Department of Environmental Protection

October 17, 1996

Re: Prilled Monoammonium Phosphate Plant - Ft. Meade
Permit No. AC53-260190 (PSD-FL-222)

This is an evaluation of the information presented in the September 26 and October 1, 1996 letters from Koogler & Associates and Jacobs Engineering Group, Inc., concerning PSD-FL-222 for the US Agri-Chemicals (USAC) Prilled MAP Plant. Before addressing the details of USAC's latest submittals, a review of the history of this permit is summarized below.

Figure 6. NTU vs. pressure loss. L/G and V_c are taken as parameters. $T_{GE} = 60^\circ\text{C}$ and $Lv/Dc = 8.5$.

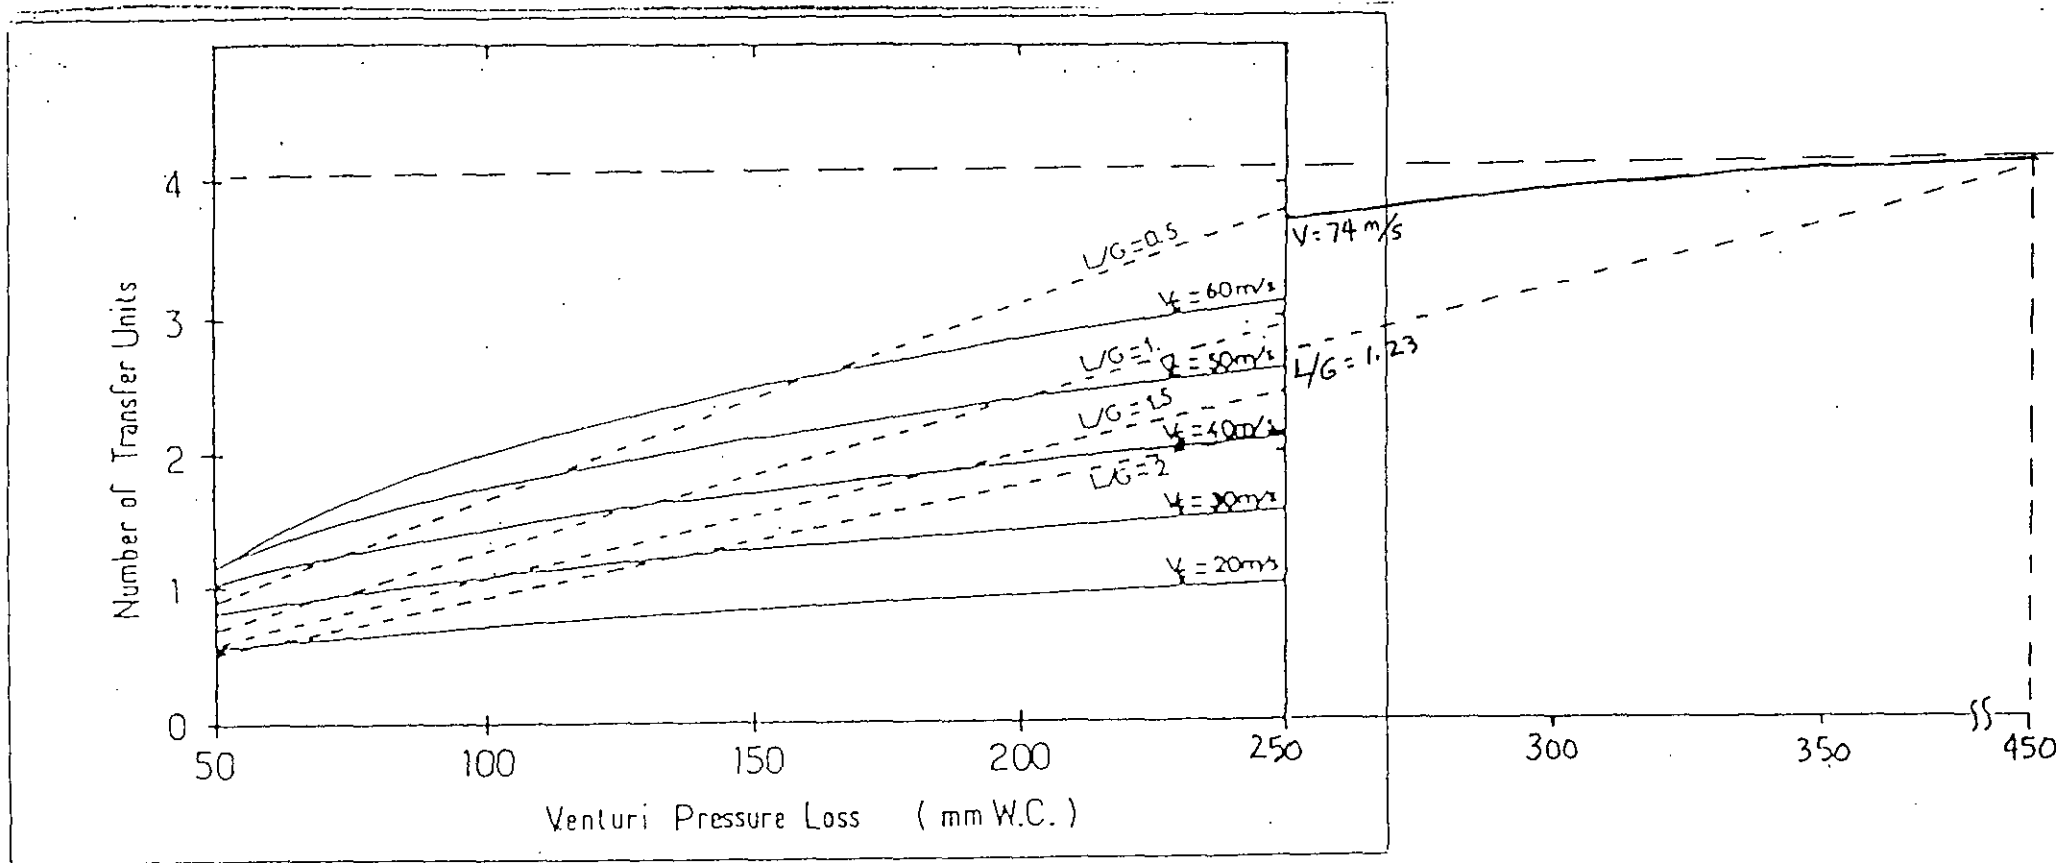
The Department cannot agree with these latest calculations submitted by Jacobs. The extrapolated curve that Jacobs drew on Figure 5 of the article is not relevant for their unneutralized scrubbing slurry. Secondly, the data in Figure 5 cannot be infinitely extrapolated at constant L/G because the short contact time in the venturi throat prevents the mass transfer from increasing beyond a certain gas velocity.

Attached is an extrapolation performed on Figure 6 which shows the variation of transfer units with the same variables as in Figure 5 but with pressure drop added. As shown, a maximum of 4.0 transfer units is obtained for the conditions specified by Jacobs, again keeping in mind that this is applicable only for neutralized water. The highest actual test result reported in the article was 3.6 NTU with neutralized water, therefore, the Department's 2.7 NTU estimate is reasonable for the high-solids scrubbing slurry Jacobs has proposed.

The limitations on gas/liquid mass transfer in a venturi scrubber result primarily from the short contact time. Since the time is so short, there is a point beyond which mass transfer will not increase as additional transfer area is created by the smaller liquid drops formed with increased pressure drop. Consequently, transfer unit values cannot be extrapolated as Jacobs attempted.

Jacobs' venturi design will not accomplish the fluoride removal that they have represented to the Department. Therefore, the USAC proposal is not representative of BACT for fluorides. The final emission limits for the MAP prill tower and cooler should be the same as proposed in the Department's July 3 letter.

Figure 5. Variation of NTU with L/G ratio and V_G calculated from the empirical law. Using $T_{in} = 60^\circ\text{C}$ and saturated gases: $L_v/D_c = 8.5$.

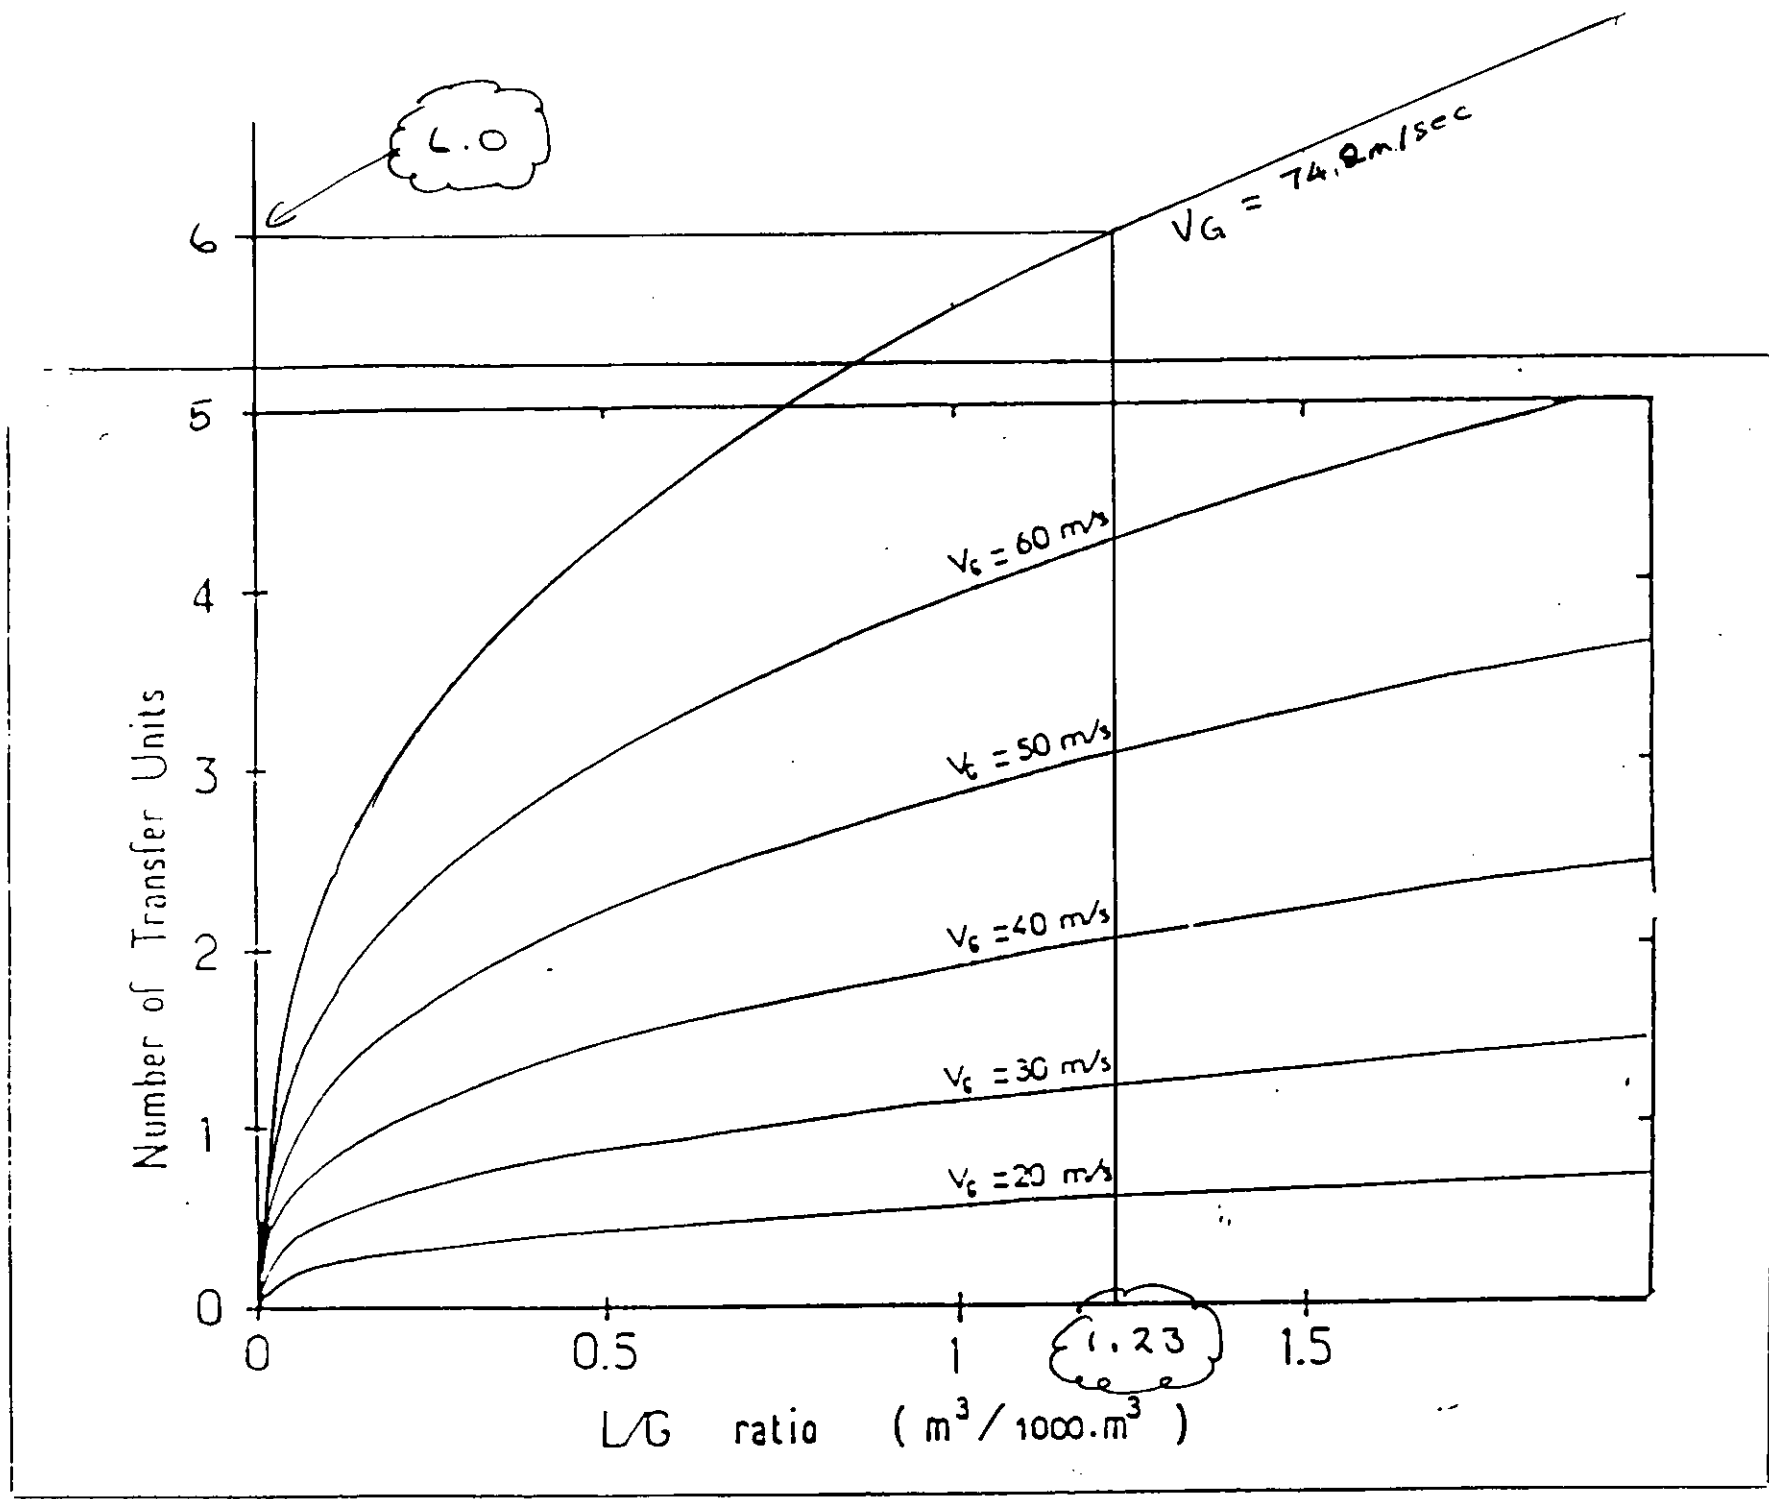
Figure 5 of this article shows the number of transfer units at five for a throat velocity of 60 meters per second and a liquid to gas ratio ($m^3/1,000m^3$) of 1.9. Our specification (attached) shows a pressure drop of 19 inches of water, an irrigation rate of 900 gpm and a gas flow of 97,626 acfm.

Using Figure 3 and Figure 5 of this article, these data correspond to a gas velocity in the throat of 74.5 meters per second, a liquid to gas ratio of 1.23 and six transfer units. This corresponds to an approach to equilibrium at 1.7% of the equilibrium vapor concentration
